PROJECT TITLE: Rancho del Rey-Spa I

CASE NO: EIR-87-1

**EVALUATION OF THE ADEQUACY  
OF THE ENVIRONMENTAL IMPACT REPORT  
FOR THE REVISED  
RANCHO DEL REY SECTIONAL PLANNING AREA (SPA)  
I PLAN**

FIGURE 1

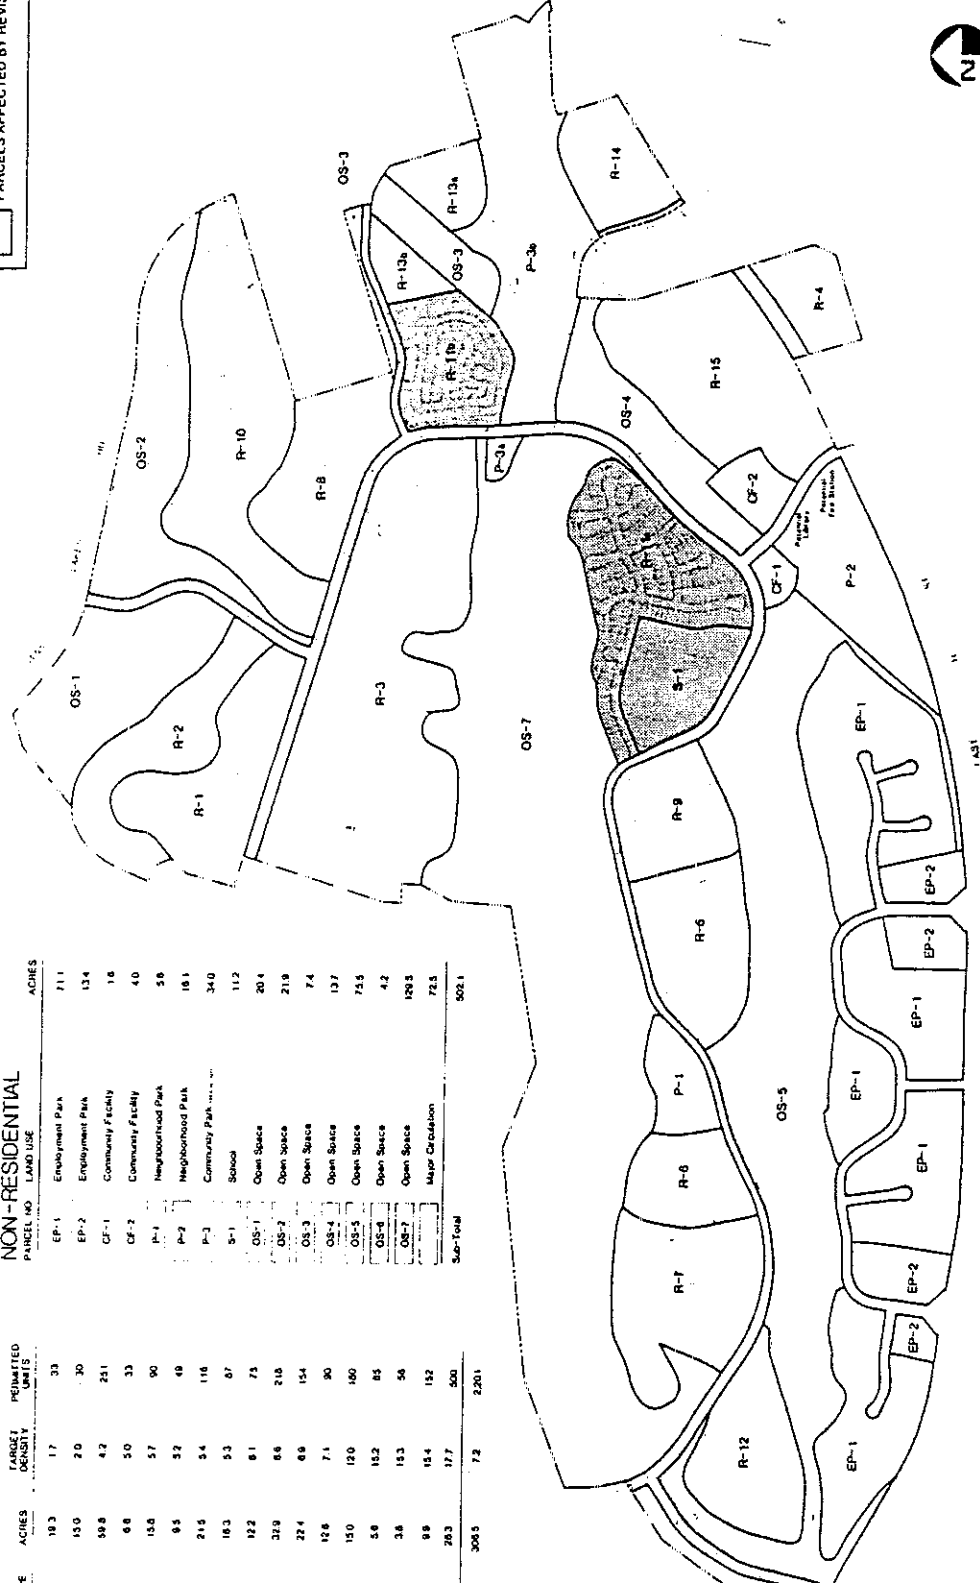
As discussed in Section 1, the revised Rancho del Rey SPA I land use plan retains the majority of the elements of the original plan. Under the revised plan (Figure 1), the school would be located along the internal loop road and the residential units that are displaced by the school would be relocated to the original school site. As a result of this change, an additional 1.4 acres would be developed with residential land uses, with a corresponding reduction of 1.4 acres in the size of the school site. While the total number of residential units on the project site would remain the same under the revised plan, the number of single-family "cottage" units would be increased by 90 with a corresponding decrease in the number of duplex units. Because the land use designations would remain compatible with surrounding land uses and with applicable land use policies, these changes in residential land use categories do not constitute a significant change from the original plan.

City staff have raised concerns regarding the configuration of land uses in the revised plan. Specifically, these concerns are related to the interface between existing offsite residences and the proposed park site (adjacent to the school) and access from the school to the park. The details regarding the interface between the land uses in the revised plan are currently being resolved between the City and the applicant. Assuming that these details are resolved to the satisfaction of the City of Chula Vista, no significant impacts related to land use are expected to result. Additionally, it is assumed that no residential construction will take place within the established SDG&E easement and that appropriate measures will be taken to insure that necessary access to utility facilities will be negotiated with the appropriate agencies.

The EIR analysis is adequate; the revised project does not differ significantly from the original project in land use configuration or in its compatibility with applicable land use plans.

**FIGURE 4-J-1**

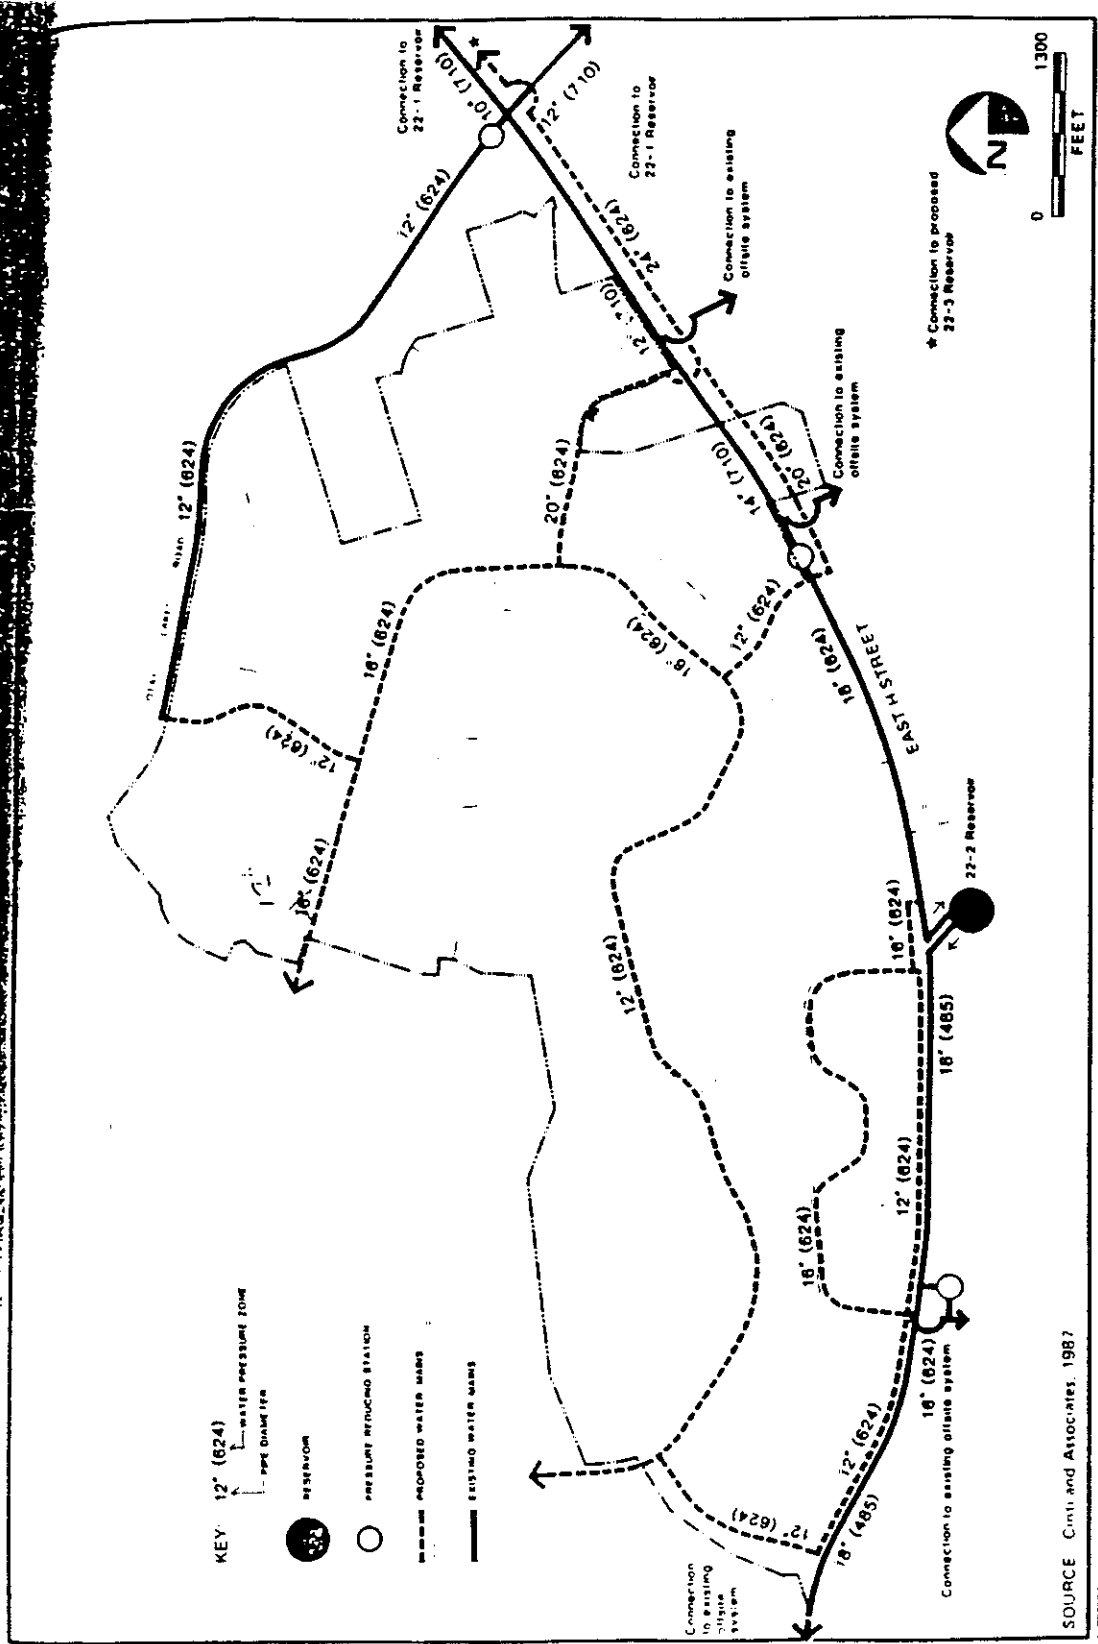
In general, the description of the existing conditions is accurate except for the last sentence of the last paragraph on Page 4-147. It appears that this sentence is out of context. On Page 4-149, the 16" main in the 524 zone in the northern loop, west of the intersection between the 12" and 16" mains, should be 12". A copy of Figure 4-J-1 is attached for further clarification.
